Work Order ID - 68701

Item Name: Replacement Skidtube

DESIGN	DRAWN BY	DART AEROSPACE LTD HAWKESBURY, ONTARIO, CANADA	
CHECKED	APPROVED	DRAWING NO. D2580	REV. D SHEET 1 OF 3
DATE 07.02.27		TITLE 205 SKIDTUBE ASSEMBLY	SCALE NTS

DRAWING NO.	TITLE	REV. D	DART AEROSPACE LTD	D.E.O. NO.	SHEET NO.	SCALE
D2580	205 SKIDTUBE ASSEMBLY		ENGINEERING ORDER	D2580-D-1	SHEET 1 OF 1	NTS

SECTION D-D
NOT TO SCALE

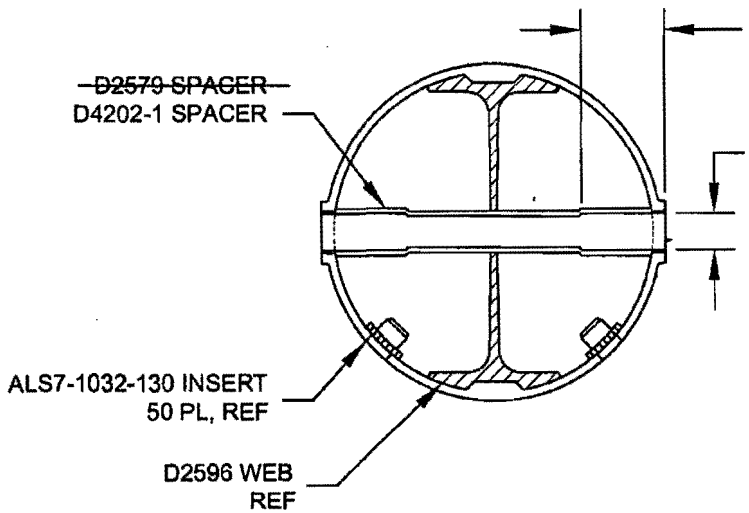
PURPOSE:
CHANGE ALL WELDED CROSSBOLT SPACERS TO SWAGED SPACERS

CHANGE:
PARTS LIST IS AMENDED AS FOLLOWS:

WAS

QTY -041	QTY -045	PART NUMBER	DESCRIPTION
20	24	D2579	CROSS BOLT SPACER

SECTION D-D & SECTION H-H ARE AMENDED AS FOLLOWS:

AFTER DRILLING AND BENDING ASSEMBLY
PERFORM THE FOLLOWING FOR Ø0.508 HOLES ONLY:

~~1. CHAMFER HOLE 0.050 X 45°~~
~~2. INSERT D2579 SPACER (20 PLACES)~~
~~3. WELD INTO PLACE AND GRIND FLUSH~~
~~4. C'BORE D2579 SPACER TO Ø0.437 X 1.00 DEEP~~

IS

20	24	D4202-1	SPACER

1. INSERT D4202-1 SPACER, 20 PL (-041) OR 24 PL (-045)
2. SWAGE TO Ø0.437 X 1.00 DEEP PER QSI 002
3. TRIM / GRIND FLUSH PER QSI 002
